[Docket No. FAA-2013-0879; Directorate Identifier 2013-NE-30-AD; Amendment 39-17694; AD 2013-24-17]

Airworthiness Directives; General Electric Company Turbofan Engines

SUMMARY: We are adopting a new airworthiness directive (AD) for General Electric Company (GE) GE90-110B1 and GE90-115B turbofan engines with certain high pressure compressor (HPC)

Figure 1

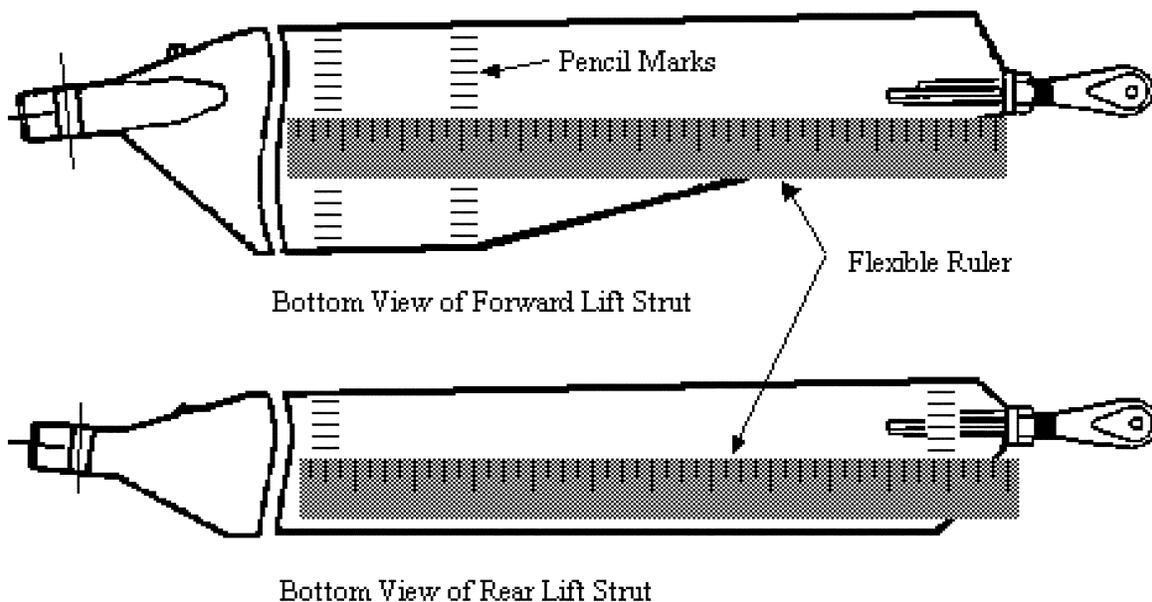
5. Take readings inside each square on the grid or at 1/4-inch increments along the ruler and record the results. When taking a thickness reading, rotate the transducer slightly back and forth and experiment with the angle of contact to produce the lowest thickness reading possible. Pay close attention to the A-scan display to assure that the thickness gate is triggering off of maximized backwall echoes.

• NOTE: A reading shall not exceed .041 inch. If a reading exceeds .041-inch, repeat steps 13 and 14 of the INSTRUMENT SETUP section before proceeding further.

• NOTE: The strut wall contains a fabrication bead at approximately 40% of the strut chord. The bead may interfere with accurate measurements in that specific location.

8. A measurement of 0.024-inch or less shall require replacement of the strut prior to further flight.
